Development Special Use Permit #2019-0022
4643 Taney Avenue- Douglas MacArthur Interim Swing Space

Application	General Data	
Project Name: Patrick Henry / Douglas MacArthur Interim Swing Space	PC Hearing:	November 7, 2019
	CC Hearing:	November 16, 2019
	If approved, DSUP Expiration:	November 16, 2024
	Plan Acreage:	13.82 acres
Location: 4643 Taney Avenue	Zone:	R-12 Single-Family Residential
	Proposed Use:	Temporary Reuse of Elementary School
	Dwelling Units:	n/a
	Gross Floor Area:	232,595 square feet (INT Use Only)
Applicant: Alexandria City Public Schools (ACPS) and City of Alexandria	Small Area Plan:	Seminary Hill/Strawberry Hill
	Historic District:	n/a
	Green Building:	n/a

Public Hearing and consideration of a request for a Development Special Use Permit and Site Plan (amending DSUP #2016-0009) for an lengthening of the time of validity under Section 11-418 of the Zoning Ordinance to allow interim use of the old Patrick Henry School building with for the students of Douglas MacArthur Elementary, during the reconstruction of the Douglas MacArthur School. The applicant also requests Special Use Permits to allow an increase in density and to exceed the maximum number of off-stree

Graphic #1: AM/PM Peak-Hour Traffic Pattern for Patrick Henry

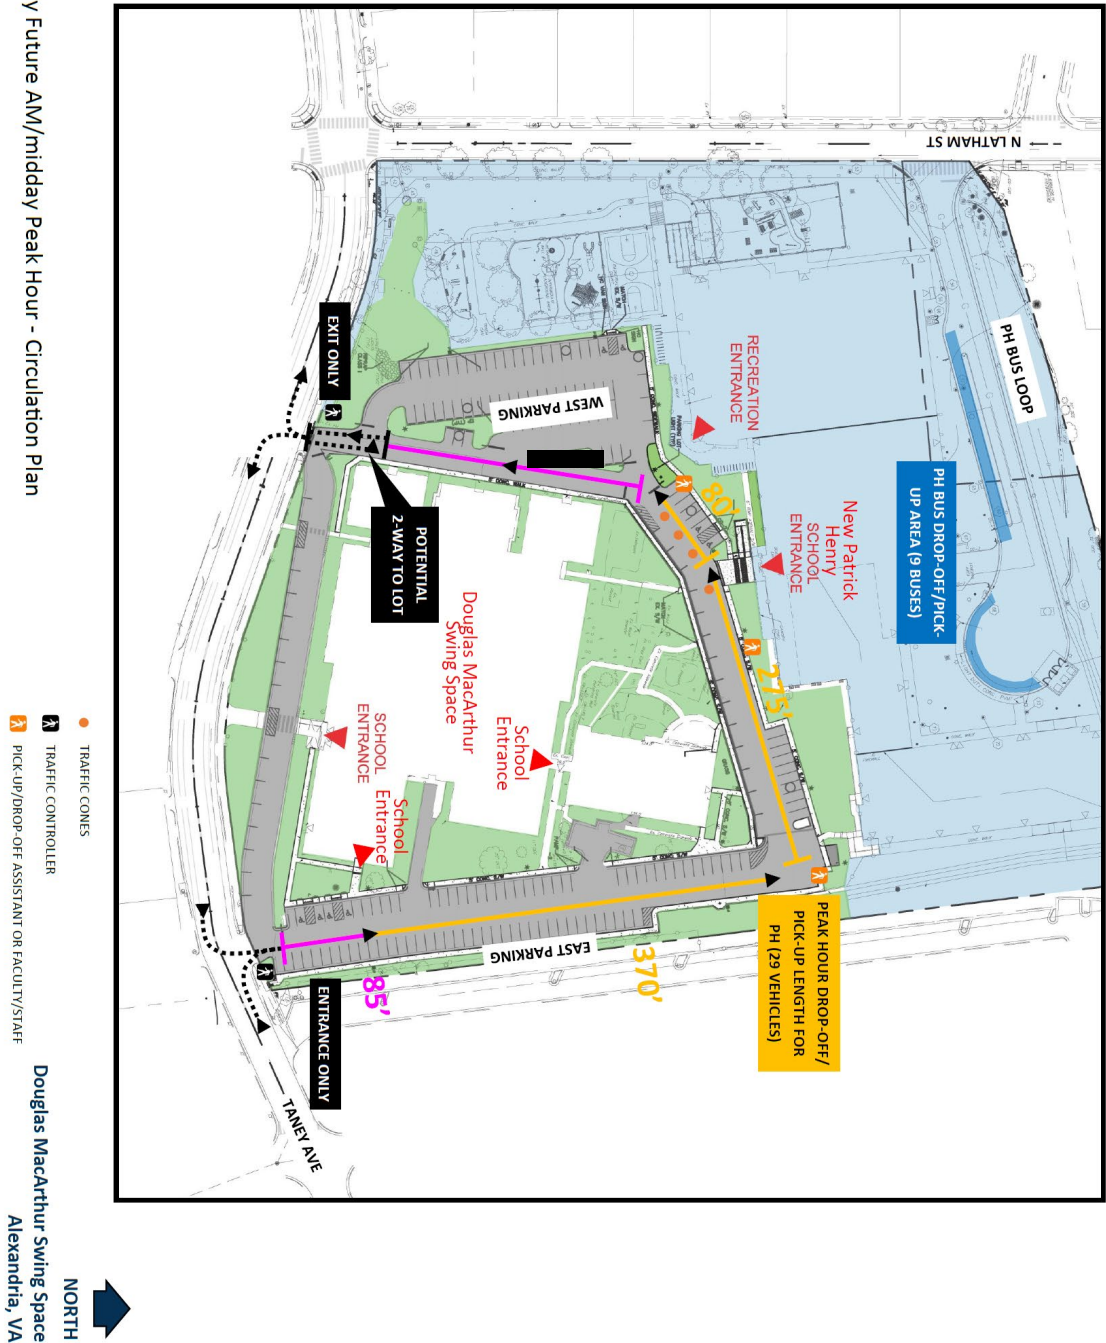
12. INT USE ONLY: Provide appropriate pavement markings and signage designating the direction in which each school's traffic should travel in one direction during the proposed alternating one-way operation plan for pick-up and drop-off. (T&ES) (Traffic)

15. INT USE ONLY: Provide adequate staff and/or personnel to provide assistance during the drop-off and pick-up period. A traffic controller (attendee) shall be stationed at each entrance/exit on Taney Avenue directing vehicles to appropriate destination according to approved Circulation Plan. (T&ES) (P&Z)

Graphic #2: AM/PM Peak-Hour Traffic Pattern for Douglas MacArthur Swing-Space

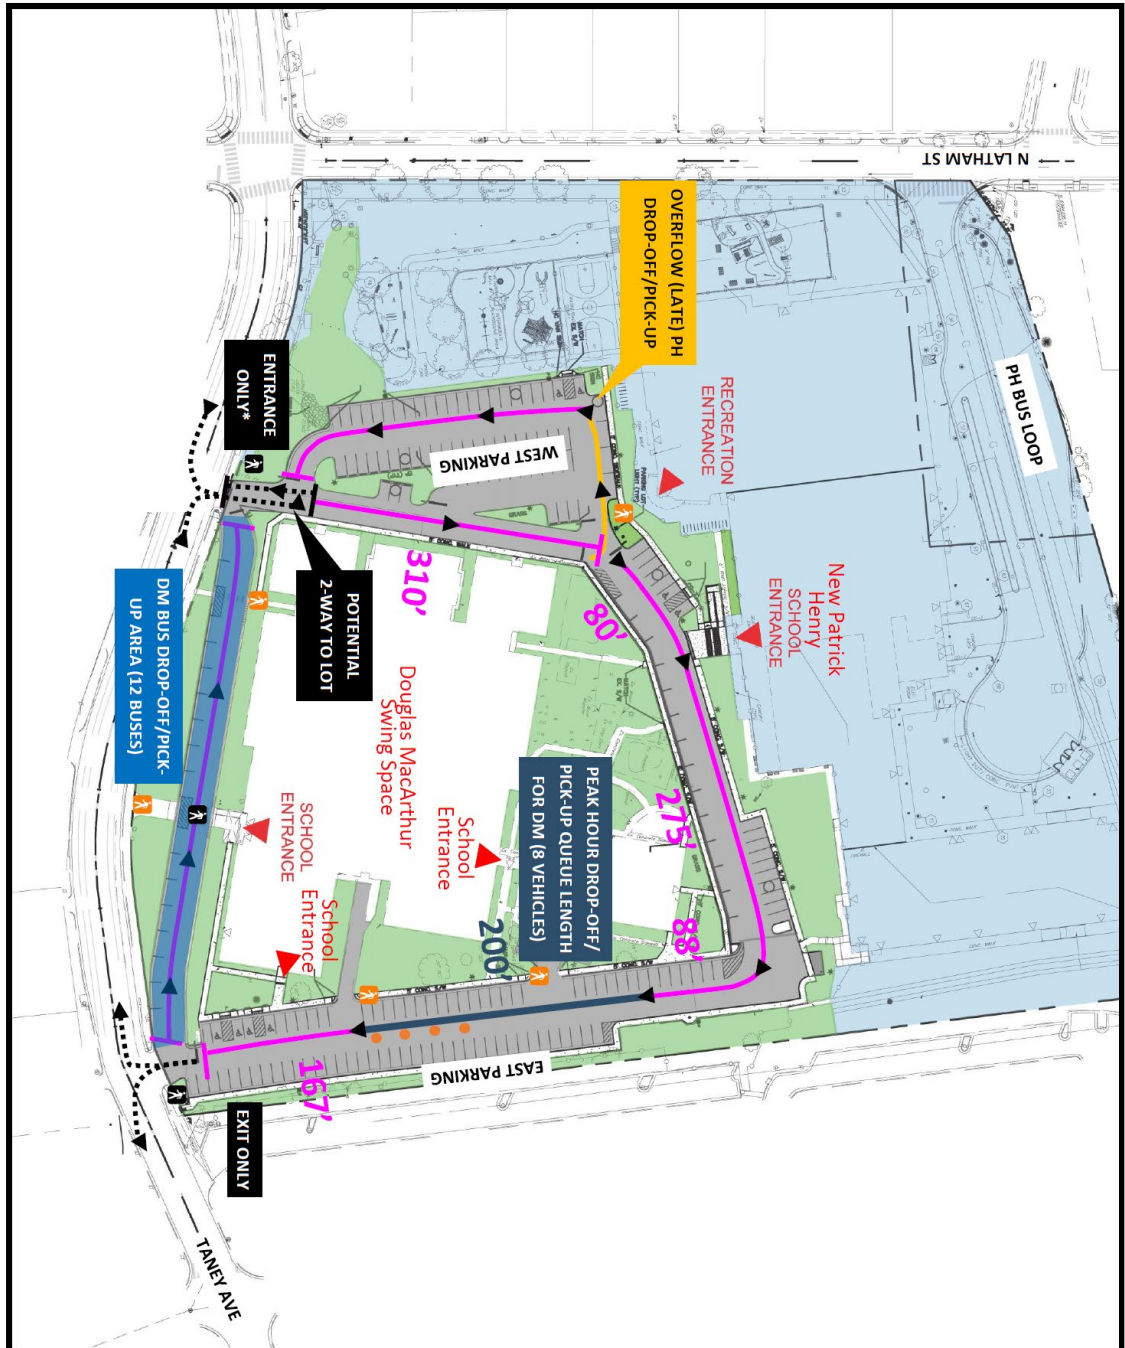
14. INT USE ONLY: In an effort to reduce delay and impacts to adjacent streets, commit to a plan to offset Patrick Henry School's bell schedules with the temporary Douglas MacArthur Elementary School, therefore staggering pick-up and drop-off times. (T&ES) (P&Z)
